REMARKS

10/690,181

AMENDMENT IN RESPONSE TO OFFICE
ACTION DATED JUNE 23, 2005

Annotated Marked-Up Drawing

FIG. 3

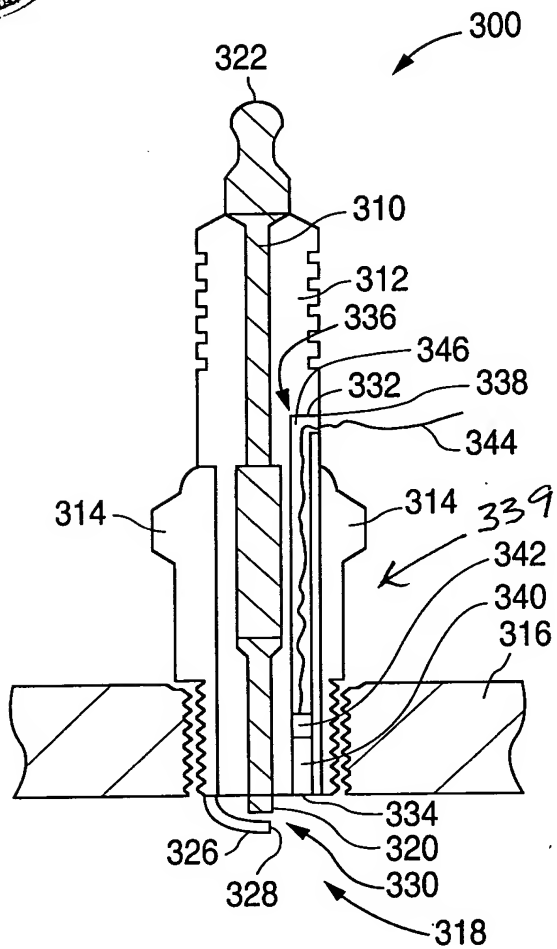
The Examiner objected to the drawings because reference number 339 is missing from FIG. 3. As a result, applicant proposes amending FIG. 3 to add reference number 339 as shown in red on a marked up copy of FIG. 3, which is attached in Appendix A. A replacement sheet including FIG. 3 is attached in Appendix B.

The Examiner also objected to the drawings because FIG. 3 does not show a hole with an L-shape as recited in claim 9. Applicant notes that hole 332, which is an L-shaped hole shown in applicant's FIG. 3, can be read to be the L-shaped hole required by claim 9. (See applicant's specification, page 4, lines 13-19.) As a result, it is believed that FIG. 3 shows an example of an L-shaped hole as required by claim 9.

With respect to claim 10, the Examiner indicated that it was unclear how the hole has an L-shape.

"In the example shown in FIG. 3, hole 332 is an L-shaped hole, although other shaped holes can alternately be used. L-shaped hole 332 begins at an opening 334 that lies adjacent to first end 320, and runs along a first line that is substantially parallel to the longitudinal axis of ceramic jacket 312 to a point 336 that lies on the outside of engine wall 316. From point 336, hole 332 runs perpendicularly away from the longitudinal axis to an opening 338 on the side of ceramic jacket 312." (See page 4, lines 13-19.)

FIG. 5

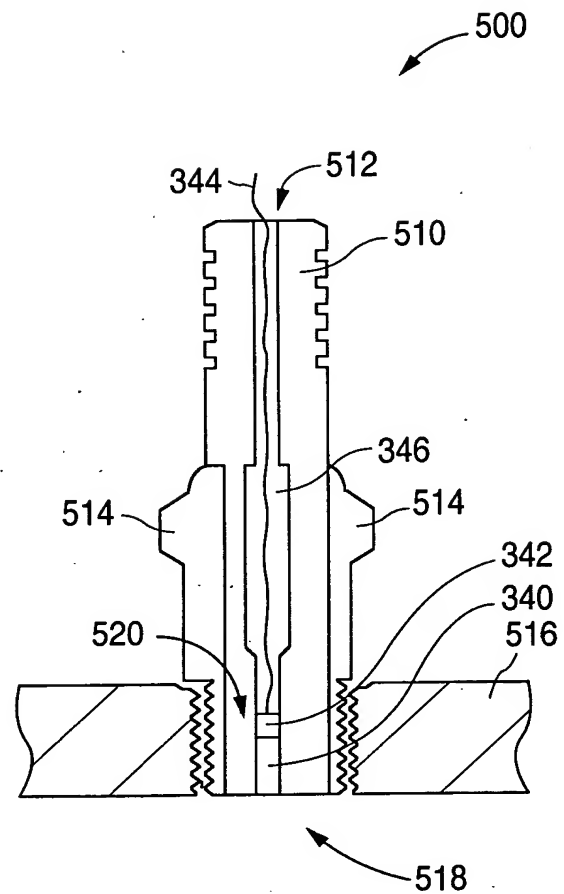
With respect to claim 11, the Examiner indicated that it is unclear how a hole can be substantially straight.

"In the example shown in FIG. 5, hole 512 is a straight hole, which has an end portion and a middle portion that is wider than the end portion, that runs along a line that is substantially coincident with the longitudinal axis of ceramic jacket 510, although other shaped holes in other locations can alternately be used." (See page 9, lines 1-5.)
